GOVERNMENT OF BERMUDA
Ministry of Public Works
Department of Works and Engineering

Ref: 61-71-200 Achilles Bay Rebuild (RFQ) – Addendum #2

PROJECT DETAILS
BDA GOV - ACHILLES BAY - STAIRCASE REPAIR

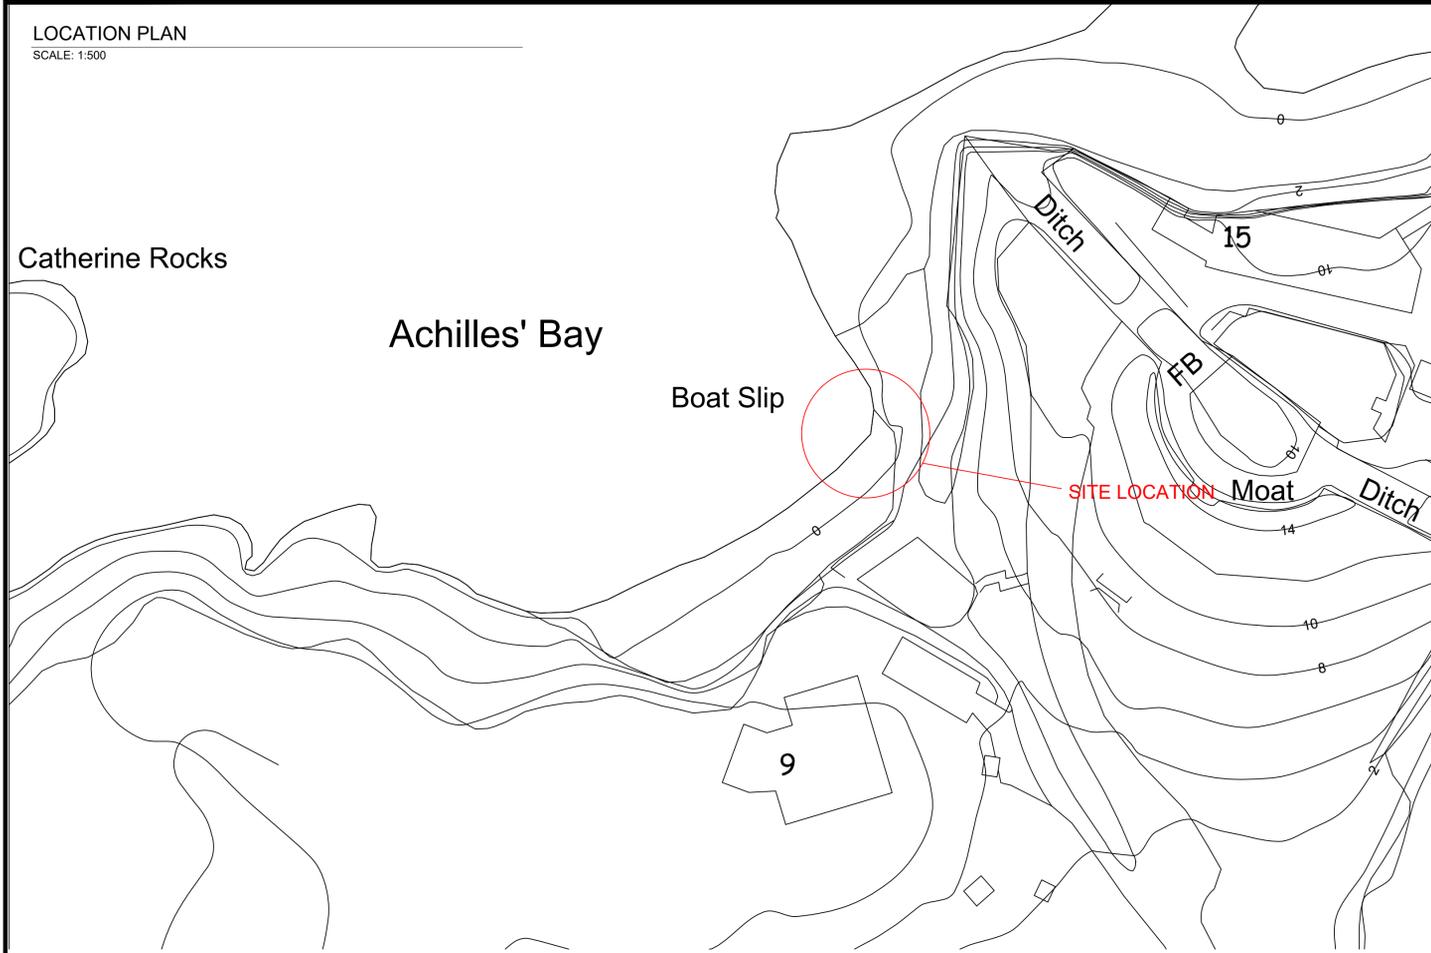
Q. Will the Contractor be provided with an area which can be used as their compound during the works?

R. The contractor may fence across the road near the fork, and use the parking lot area as laydown/staging/compound. Note that the former Blackbeard's Hideout may be undergoing renovation, so access to that site should be maintained. Any damage to the road or parking area to be made good at the contractor's expense.
